City of Portland, Maine – Building or Use Permit Application 389 Congress Street, 04101, Tel: (207) 874-8703, FAX: 874-8716

2 story 15' x 20' Addition w/ Bath

BUILDING PERMIT REPORT

DATE: 5 DEC. 96 ADDRESS: 16 Austin ST. CBL 140-F-021
REASON FOR PERMIT: To Construct a 15'x20' addition w/bath.
BUILDING OWNER: D. Hendricksen
CONTRACTOR: Eastern Shore Home Improvements
PERMIT APPLICANT: ↑
USE GROUP R-3 BOCA 1996 CONSTRUCTION TYPE 5B

Dolores HENDRICKSON

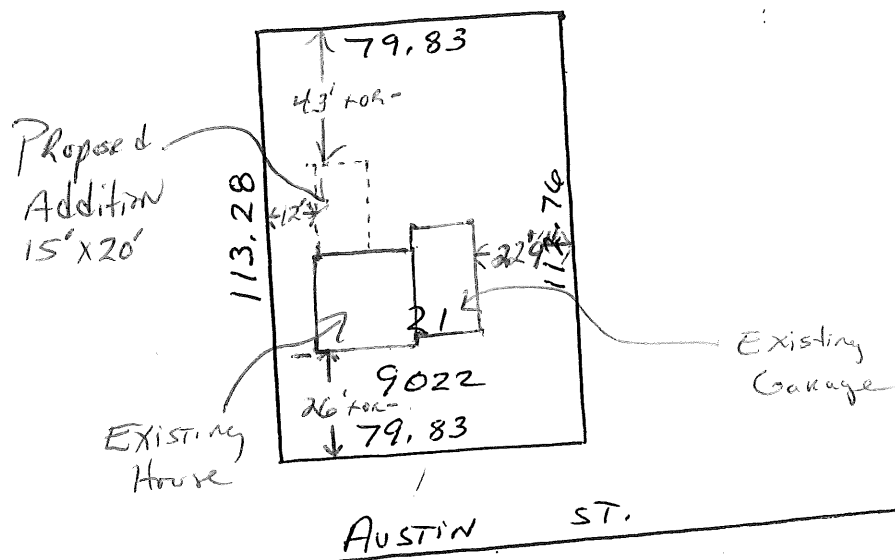
Front Yard - 25' req - 26' shown on existing here

Rear Yard - 25' req - 43' ± shown

OK → Side Yard - 14' req - using the reduction feature of: for every 1' reduced on one side, It must be added on the other side - over 22' shown on other side where 16' would be req. of

FLOOR PLANS

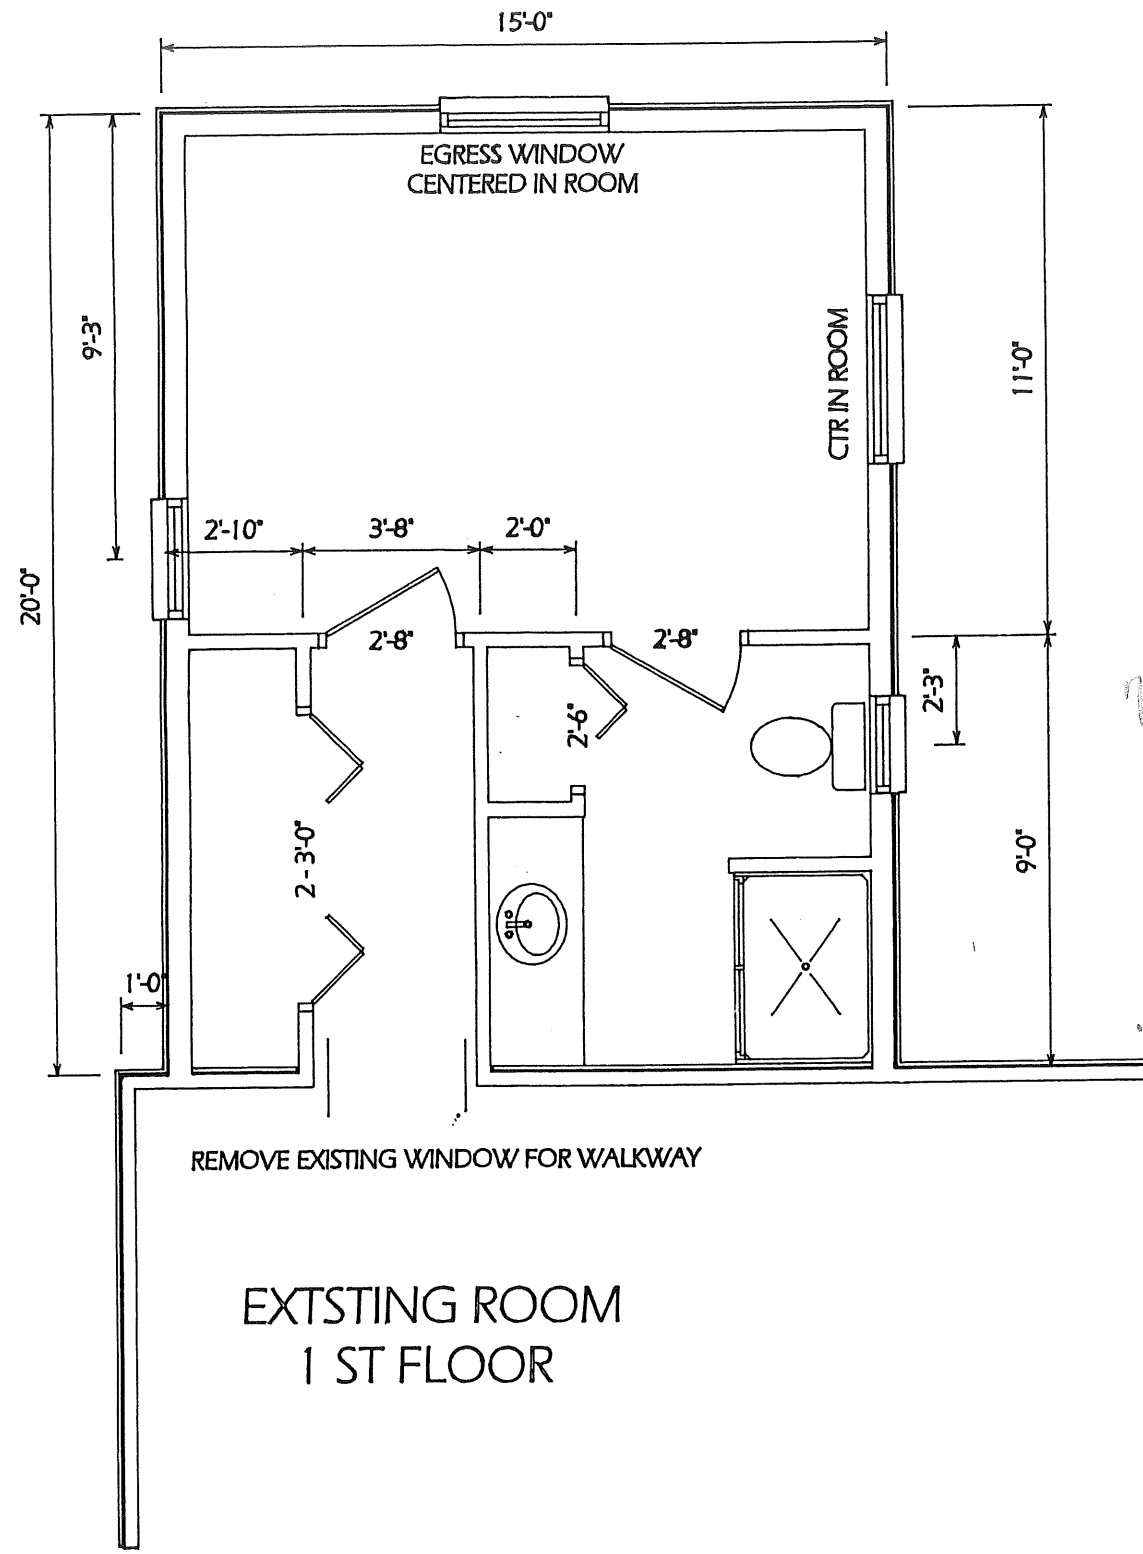
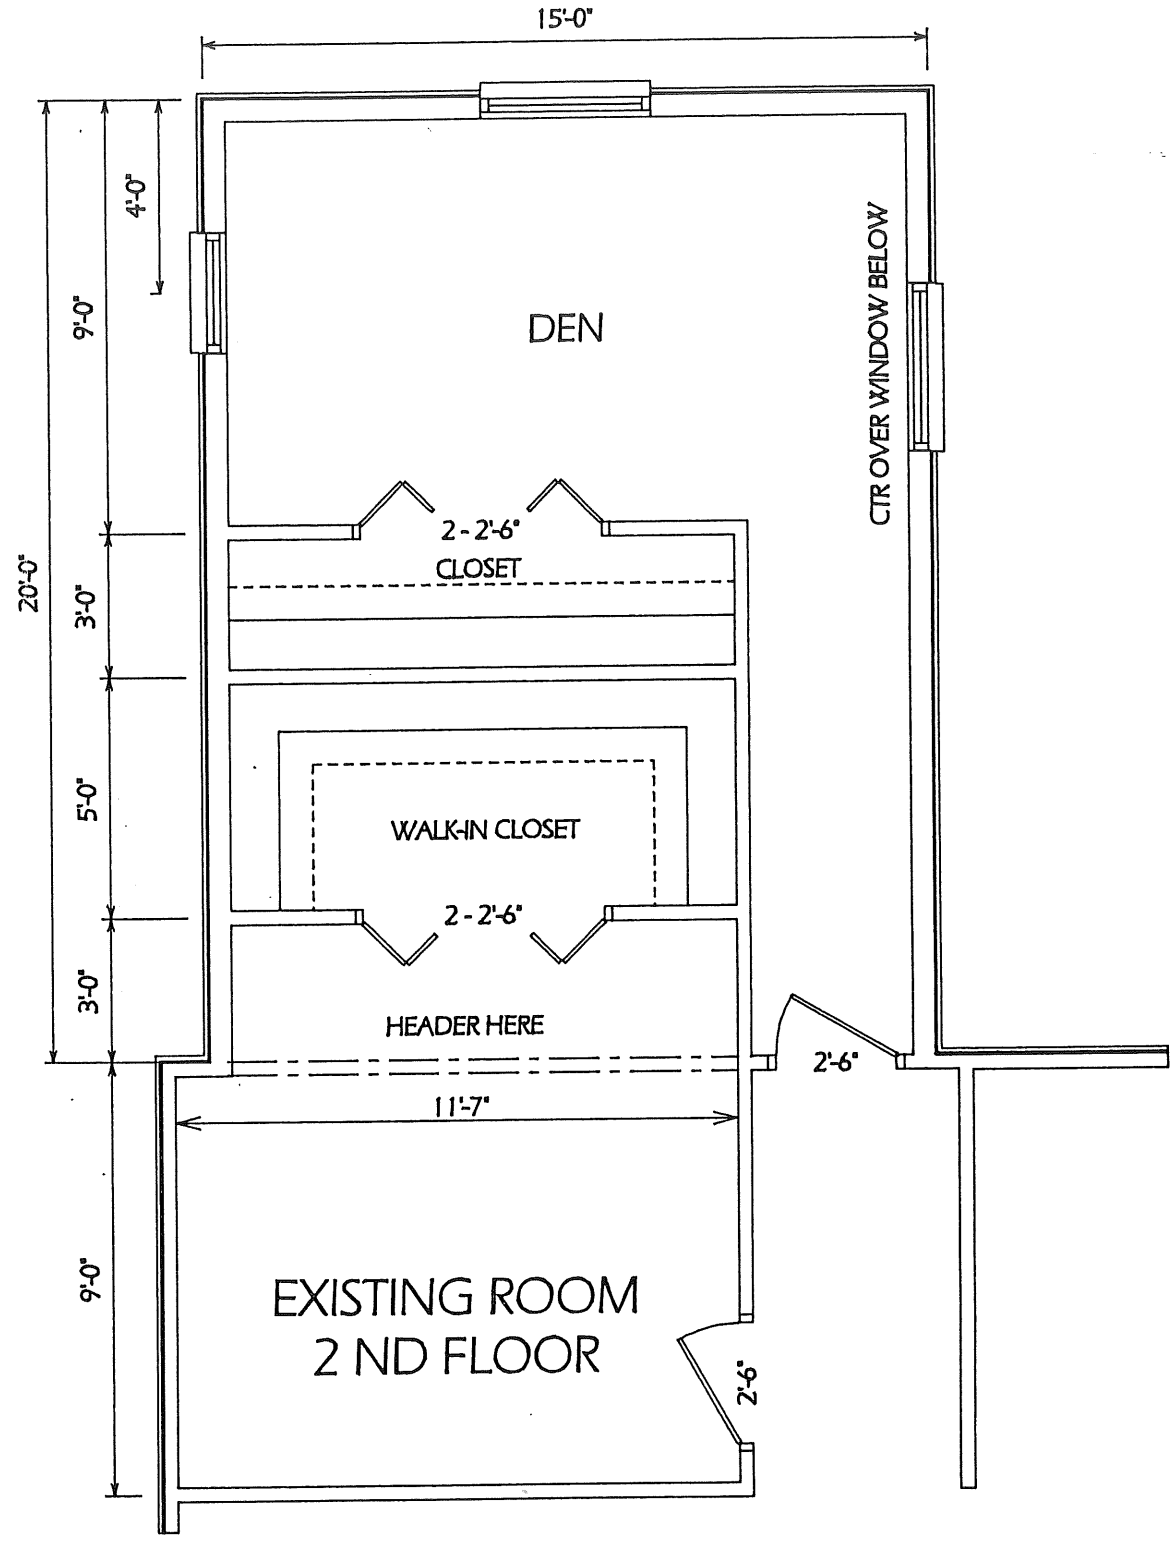
2/17/99 - Scott Called - Can't meet 7'6" Ciel Hgt on 1st floor of new addition because of line up w/ old addition - will meet 7'5 to 7'5 1/2 - discussed w/ Mike Nugent - ok (D)

7'5
7'5 1/2
